TSB - OEC

Ag Clutch cover interchange OE / AFTERMARKET

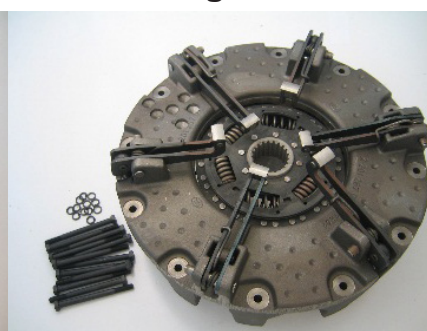
The original clutch fitted and the replacement clutch often vary between manufacturers. Ag Clutch supply the same clutch as originally fitted where possible - however this may be replaced by an alternate aftermarket version.

The alternate cover may appear slightly different, for example the original cover may have 9 bolt fixing where the aftermarket has 12 bolt fixing - the extra holes are not used.

The clutch disc fitted is sometimes upgraded or rationalized to ceramic type and the clamping method may be different.

The length of the cover fixing bolts may vary, with the alternate version requiring a new bolt set. This is only when the actual bolt fixing height of the covers can vary between the manufacturers.

Apart from the above differences these covers interchange directly, without the need for special modification.

Ag Clutch advises not to interchange the original & aftermarket clutch plates as quite often the thickness of the facings and hub offset may vary substantially between manufacturers. Mixing the components may cause release problems or premature clutch disc and cover failure.
